BOARD OF ADJUSTMENT
CASE REPORT

Case Number: **BOA-23285**

LOCATION: 4971 S DETROIT AV E

ZONING CLEARANCE PLAN REVIEW

Figure 5-1: Street Side Setback on Corner Lots

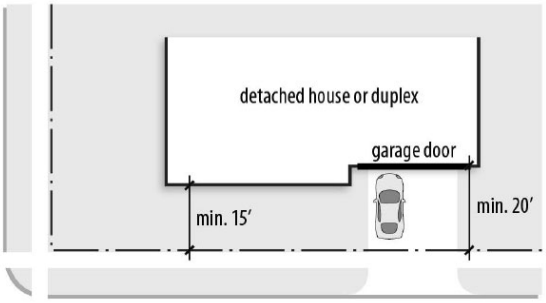
[3] For detached houses and duplexes on corner lots, the minimum side street setback along a non-arterial street may be reduced to 15 feet, provided that the minimum setback for street-facing garage doors is 20 feet or 20 feet from the back of the sidewalk, whichever is greater. The street setback specified in Table 5-3 applies along the other street.

1 Proposed Site Plan
SCALE: 1/16" = 1'-0"

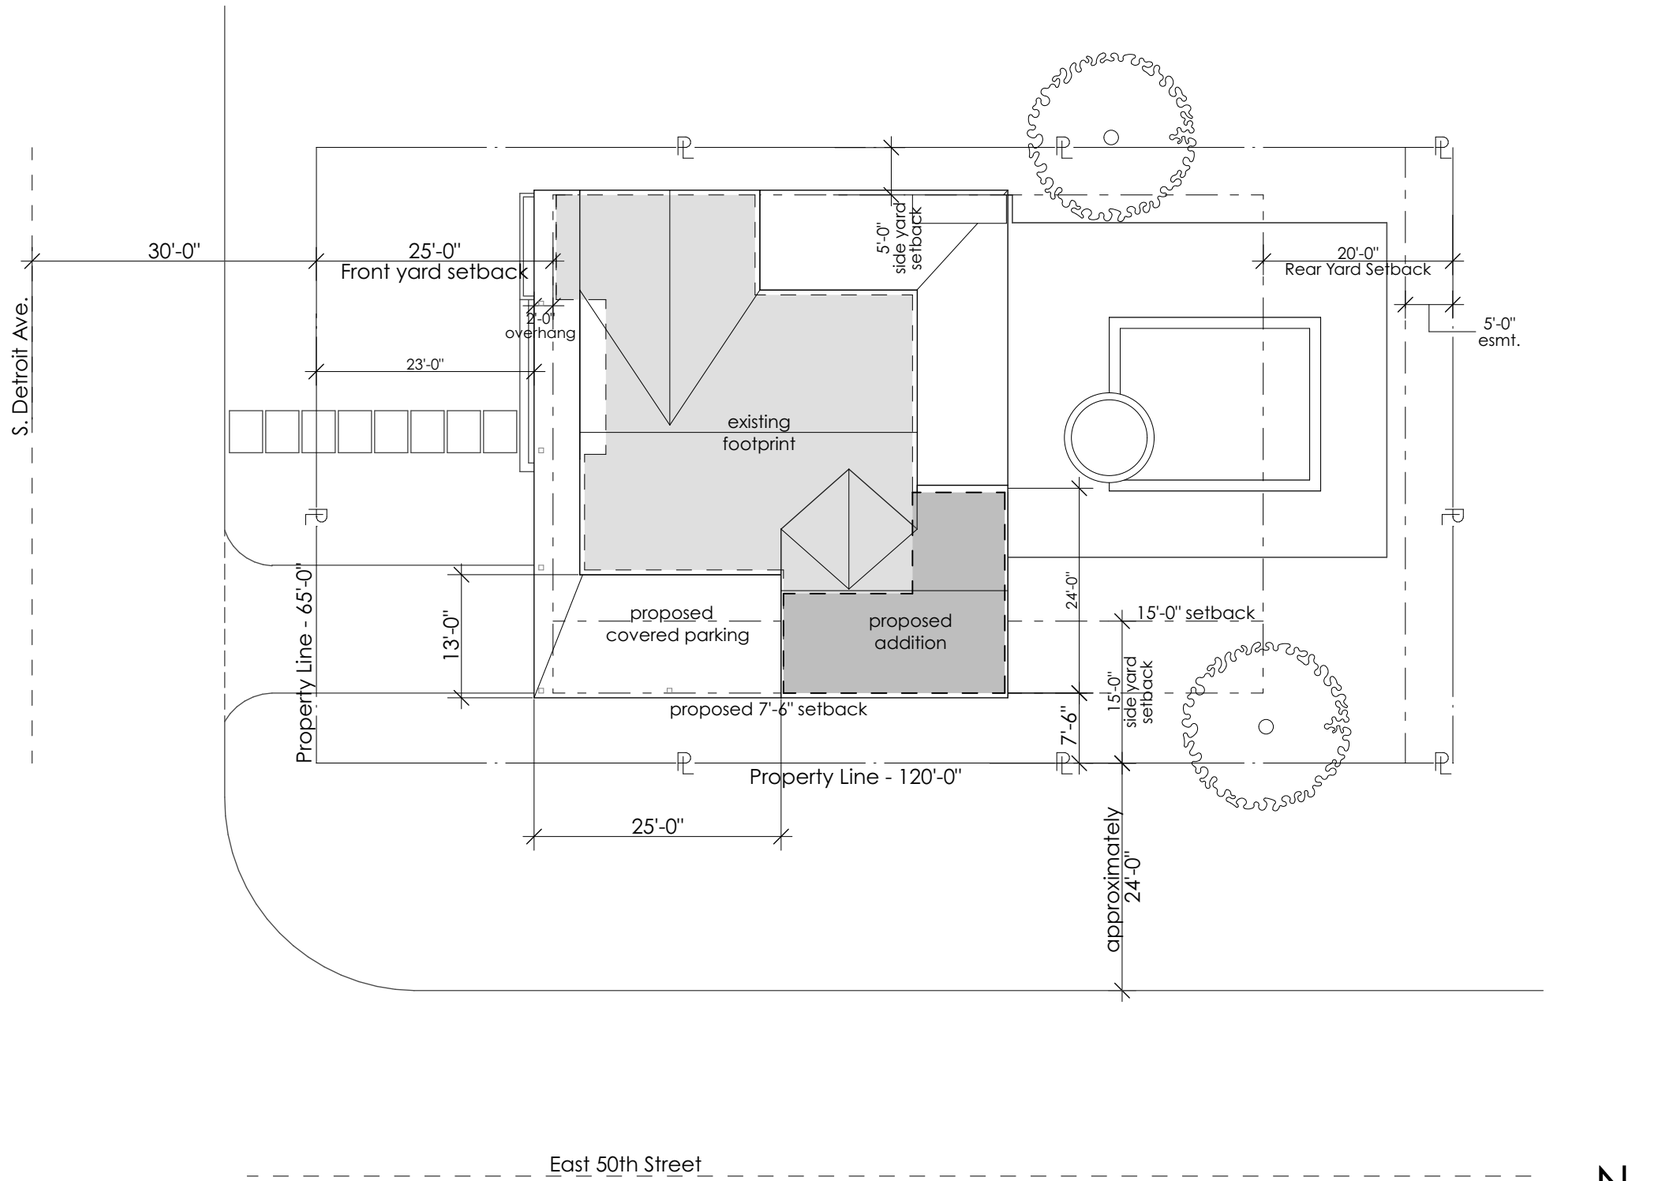
1. **Site Plan:** There is a discrepancy between the site plan and the recorded plat. The recorded plat has the lot depth as 120'; the site plan shows the lot depth as 150'. Please review and revise the site plan to the accurate dimension.

Review Comments: The required side-street setback on a corner lot in an RS-3 district is 15 feet. Please revise plans to show the addition within the required setback or apply for a variance through the board of adjustments to allow the side setback to be 7'-5".

Review comment: The proposed carport is located in the street setback and yard area and requires special exception granted by the BOA. Please contact an INCOG representative at 918-584-7526 for further assistance. Please note: If the regulations above cannot be met, you will need to address these items as part of the special exception process as the proposed structure is not in compliance with said regulations as submitted. If approved, submit a copy of the approved special exception as a revision to your application.

Requesting the south required side yard setback be reduce from 15'-0 to 7'-6"

Requesting a special exception for the covered parking to be located as designed to match the roofline of the residence w/ a 2'-0" overhang in the required front yard setback and 8'-0" in the required side yard setback if the variance request for reduction to 7'-6" is not granted.

We are requesting a variance to move the south 15'-0" setback to 7'-6" to allow for an expansion of the residence and covered parking that would meet the original setback requirements of this property.
